## Product Change Notification

### PCN-IFC-6549-2021

Business Unit	Product Line Code	Type of Change	Action	Date of Issue
IFC - Industrial Field Connectivity	BF7	Product Change Notification	Notify Distributors and Field	3/8/2021

#### Description for Product Change Notification

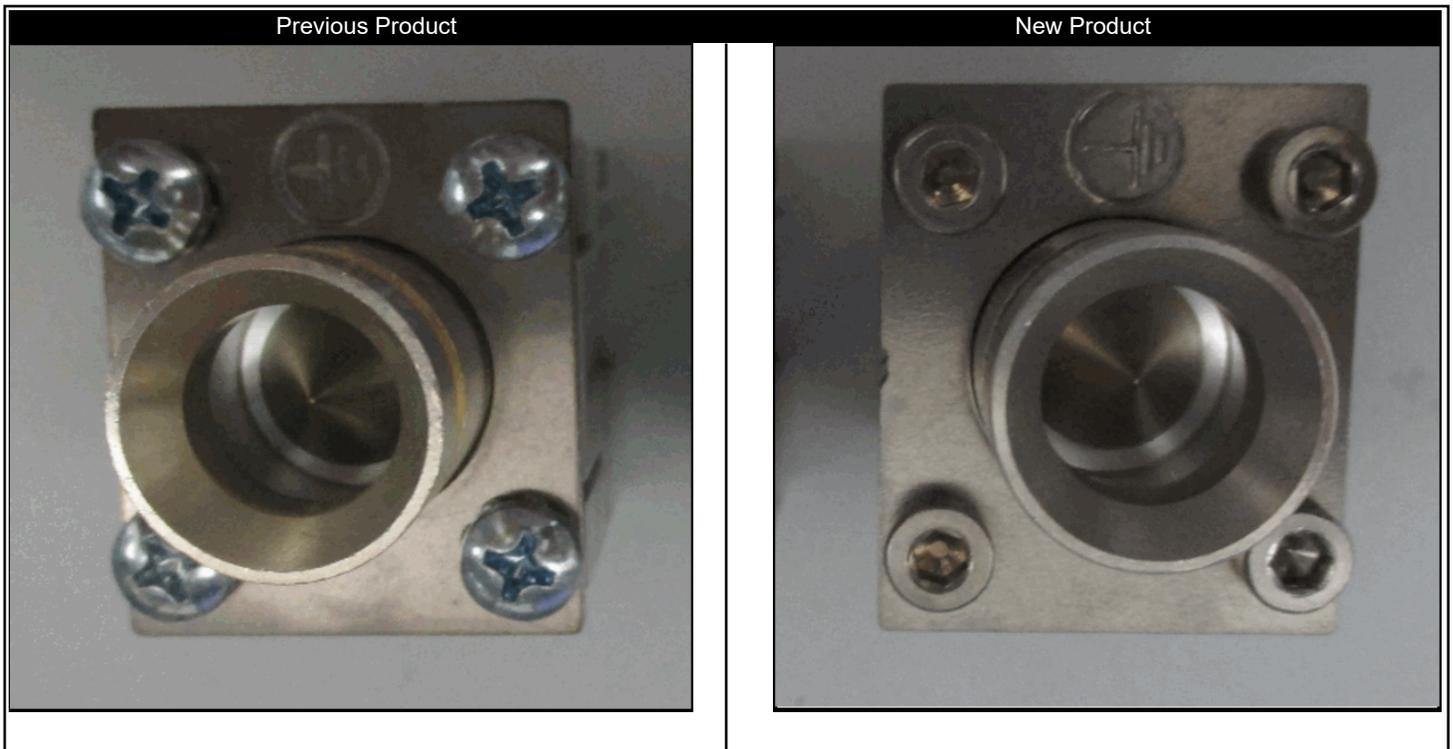
The screws for the ground plate of the HEAVYCON modular PE module have been changed from a phillips head to a size 3 hexagonal (allen) head. The new allen head screw, with vibration proof thread coating, is easier to handle during the assembly process. Additionally, the lock washer is no longer required with the new allen head screws. The new screws are made of RoHS II compliant stainless steel alloy (lead-free).
